Subject: **PALO VERDE SOLAR I, LLC'S PETITION FOR AMENDMENT  
BLYTHE SOLAR POWER PROJECT  
DOCKET NO. (09-AFC-6C)**

# BLYTHE SOLAR POWER PROJECT

**AMENDMENT**  
**(09-AFC-6C)**

## **FIGURE 2-3**

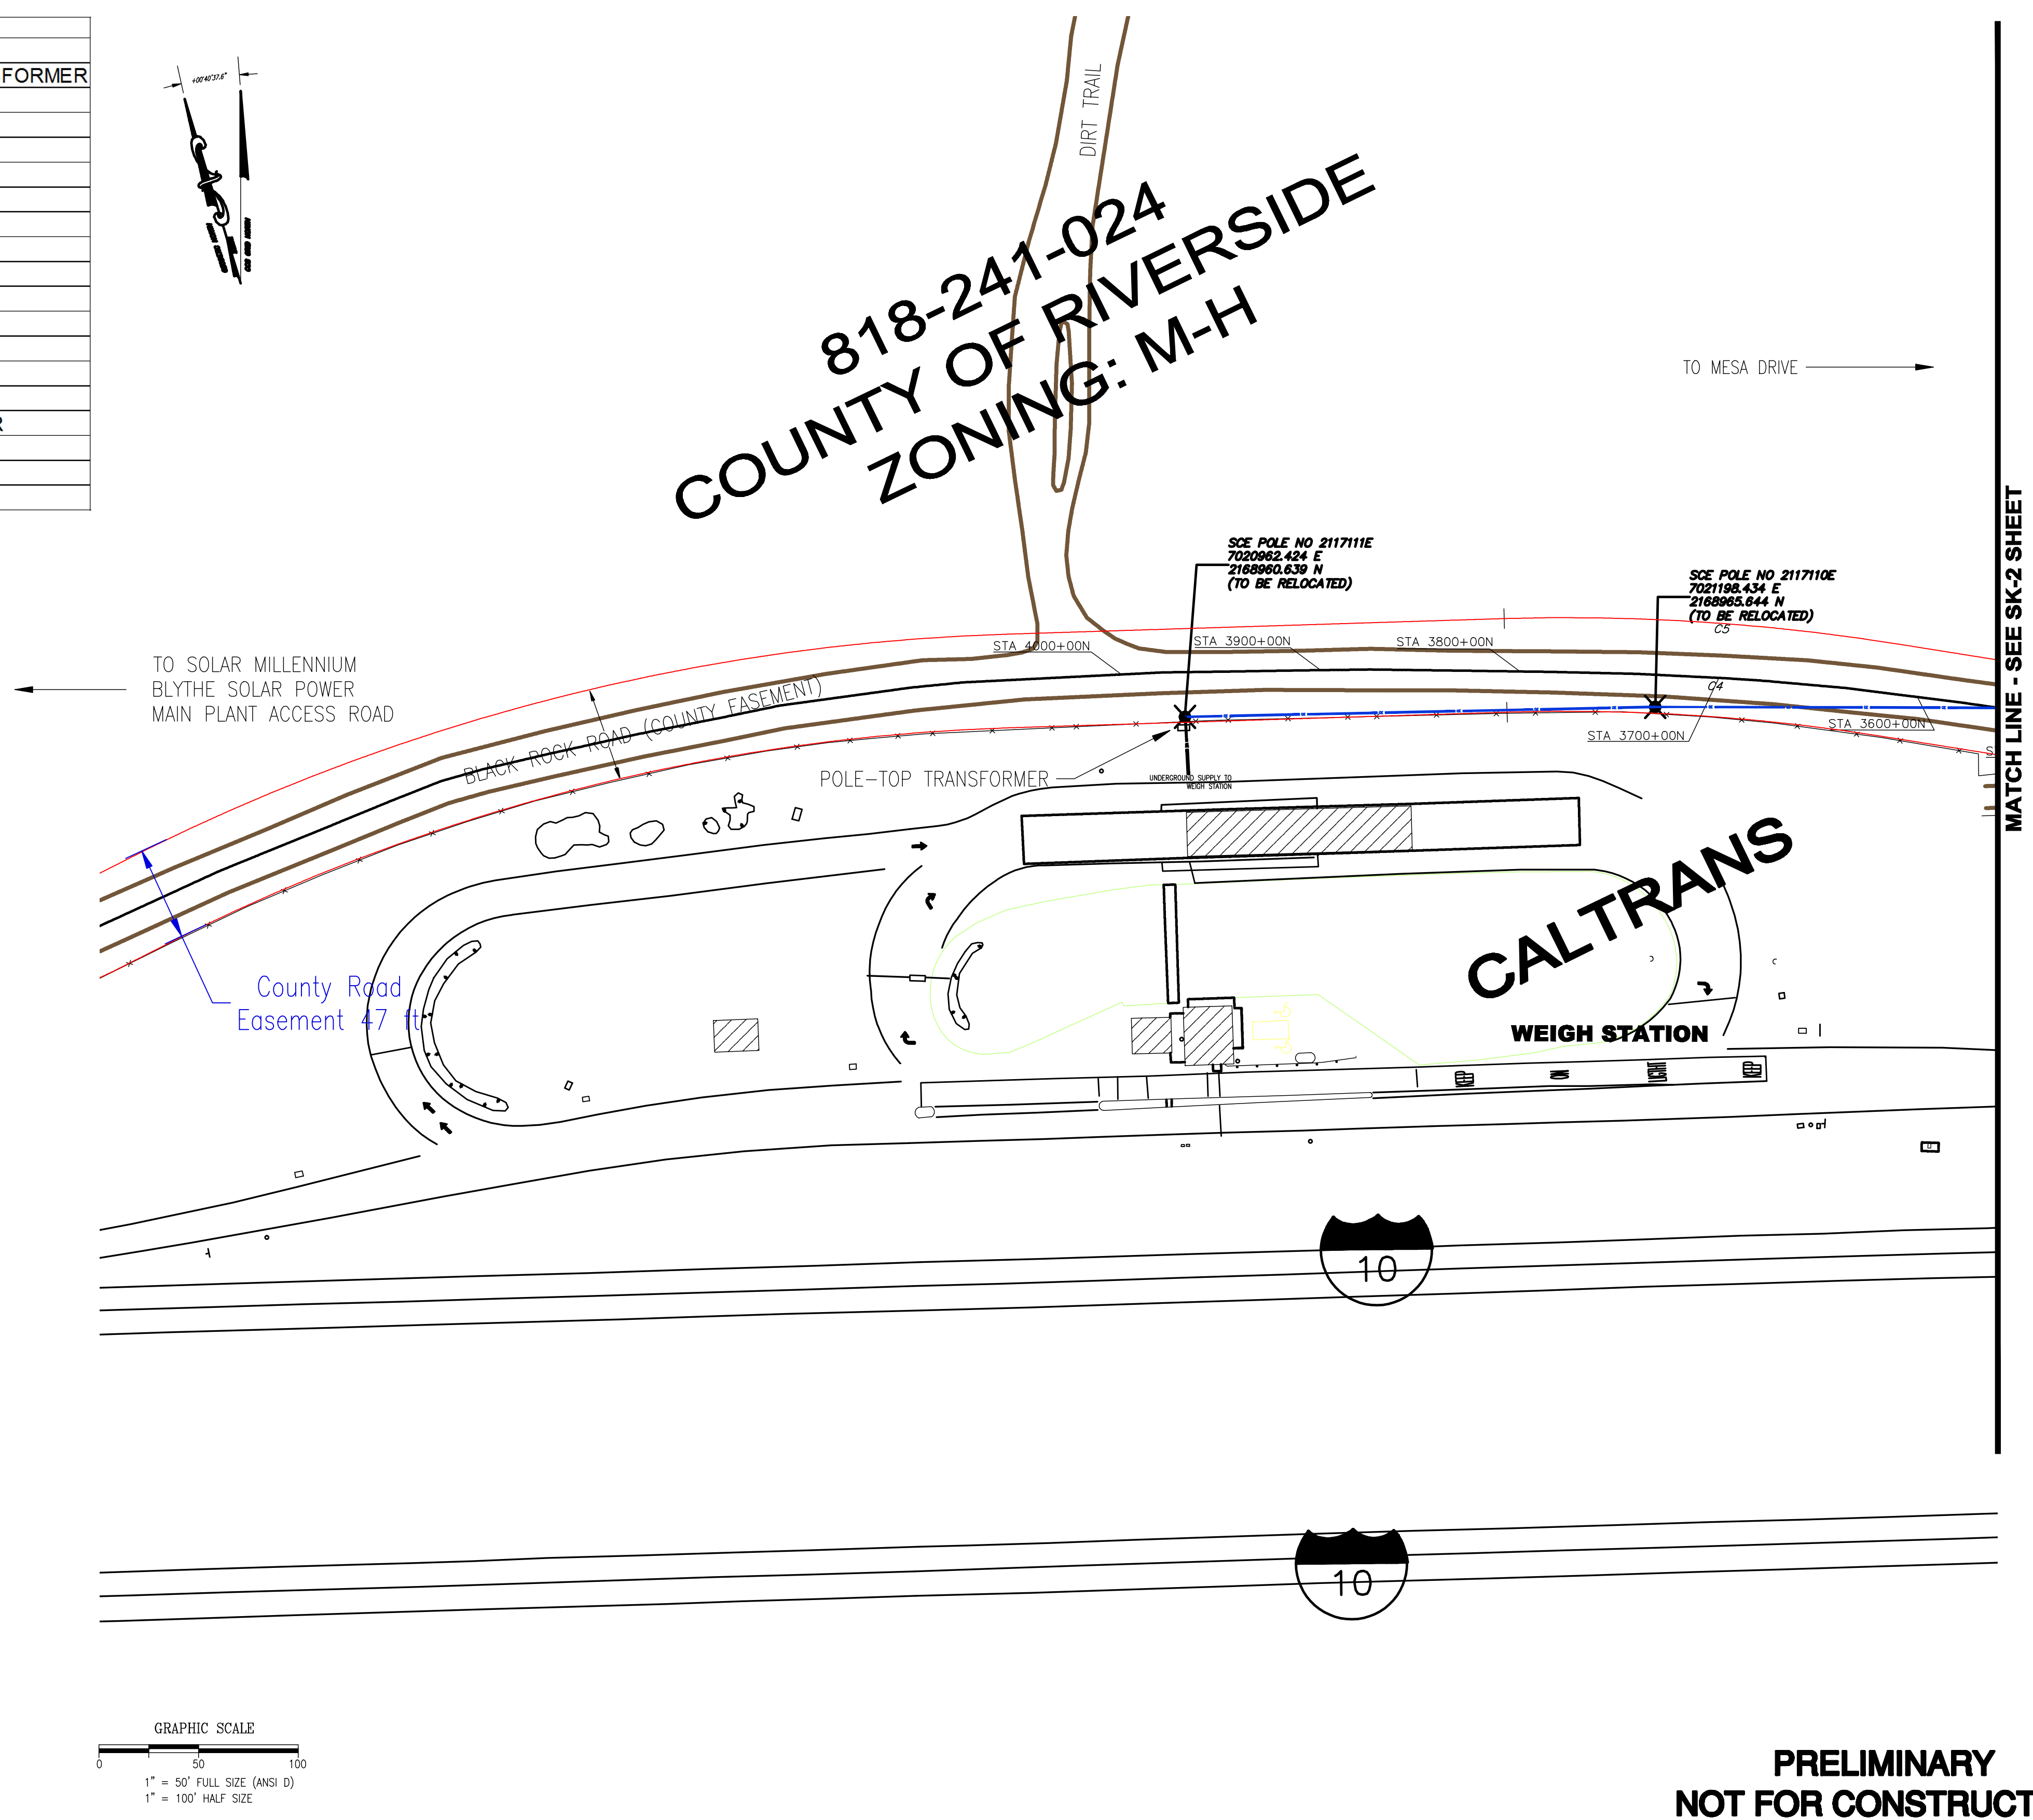
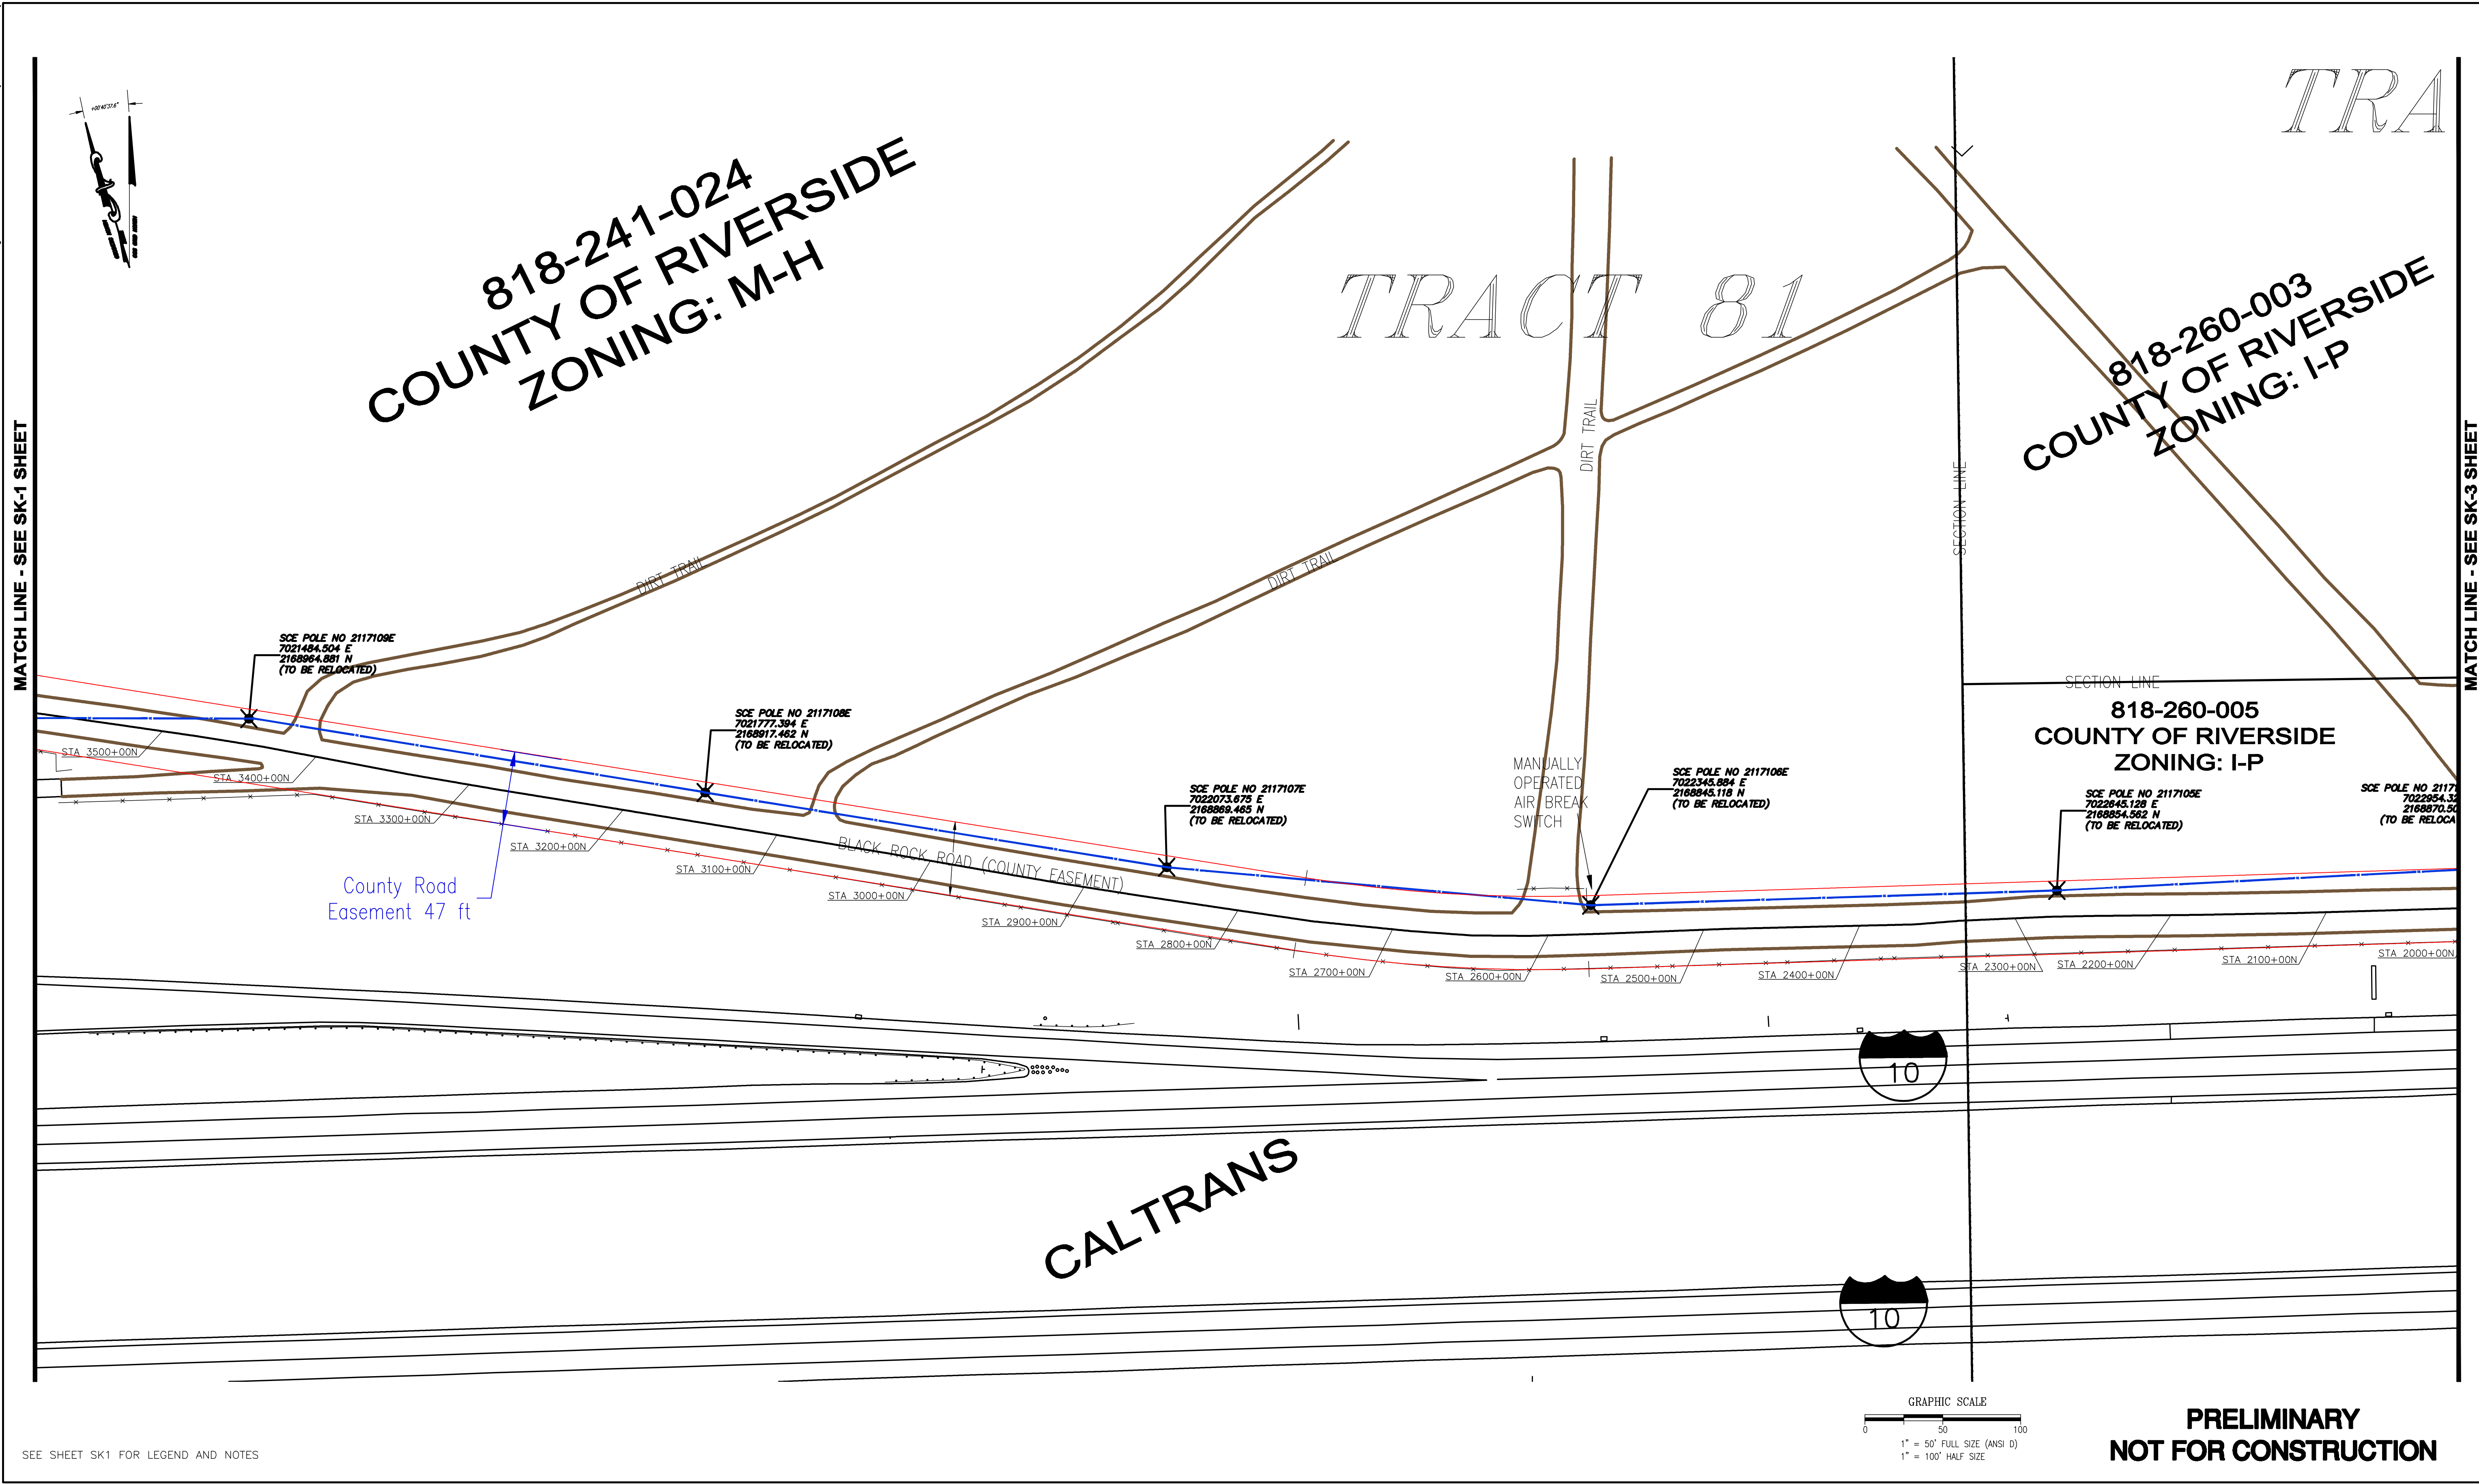
During final design of the access road it was discovered that expansion of a portion of Black Rock Road could not be accommodated without relocating some of the adjacent transmission poles supporting SCE's existing 12 kV Distribution Line that currently serves the CalTrans Weigh Station. Eighteen poles will be relocated approximately 10 to 15 feet. The work will be performed by SCE and will involve removing existing poles and either replacing them with new wood transmission poles or undergrounding. The new transmission poles may be 5 feet taller than existing and will be placed within an expansion of the existing County Right-Of-Way. **Figure 2-3** identifies the extent of the Black Rock Road transmission pole relocation.

- NOTES:**
- SOLAR MILLENNIUM TO IMPROVE BLACK ROCK ROAD WEST FROM MESA DRIVE TO MAIN PLANT ACCESS ROAD A DISTANCE OF APPROXIMATELY 1 MILE. REFER TO PRELIMINARY CIVIL DESIGN DRAWING 2008-045-CD-200 FOR TYPICAL SECTION
  - EXISTING 12KV DISTRIBUTION LINE BETWEEN POLE 2117111E AND 2295236E TO BE RELOCATED BY SOUTHERN CALIFORNIA EDISON TO CONFORM WITH MINIMUM RIVERSIDE COUNTY REQUIREMENTS AND ENABLE SOLAR MILLENNIUM CONSTRUCTION ACTIVITY
  - FINAL RELOCATED POLE LOCATIONS TO BE PROVIDED BY SCE IN ACCORDANCE WITH RIVERSIDE COUNTY STANDARDS AND SPECIFICATIONS FOR ROAD IMPROVEMENT WORKS INCLUDING ORDINANCE 461
  - COORDINATES TO NAD 83 STATE PLANE VI COORDINATE SYSTEM, U.S. SURVEY FOOT
  - SOLAR MILLENNIUM HAS COMPLETED ENVIRONMENTAL STUDIES ALONG LENGTH OF BLACK ROCK ROAD REQUIRING UPGRADE
